Our Ref: LTR001-01-19-609 Submission
Comments North Rd and Water Q

RE: SSD-10479 COMMENTS FROM SUBMISSIONS – ALTERNATIVE PROPOSALS

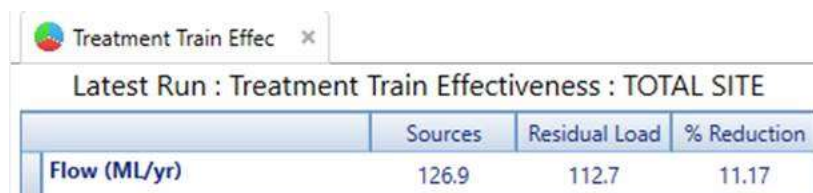
The sections show the proposed development along this boundary is expected to differ significantly between the two landowners. The resultant road centred on the boundary would be unfeasible for several reasons:

- a) The road would need to be built on or between retaining walls, requiring rigid performance barriers to mitigate safety risks.
- b) Does not allow for total construction of a complete road by either landowner thereby prevents orderly development.

- c) Does not provide efficient access to development building site on both sides of the road, which increases the costs and challenges of designing and constructing a road, as well as compromising the road frontage amenity.
- d) In this location, the intersection is too close to another proposed intersection in the draft DCP, which is only 150m north of this position on Aldington Road.
- e) The lot directly north of 200 Aldington Estate is already serviced by the local industrial elbow shaped road 150m to the north. It does not require a second access point, and should not be burdened with a second road given its relatively small size.

The design and construction of a high order road along the northern boundary of 200 Aldington is challenging and uneconomical. It is recommended to relocate the road to achieve the required traffic outcomes and allow orderly development an efficient manner to maximise use of the s7.11 funds and WSEA outcomes. The road should be reconsidered for a position where it can be incorporated into known landholdings where it makes the most of existing precinct constraints, efficient use of s7.11 contributions and especially the proximity to other intersections.
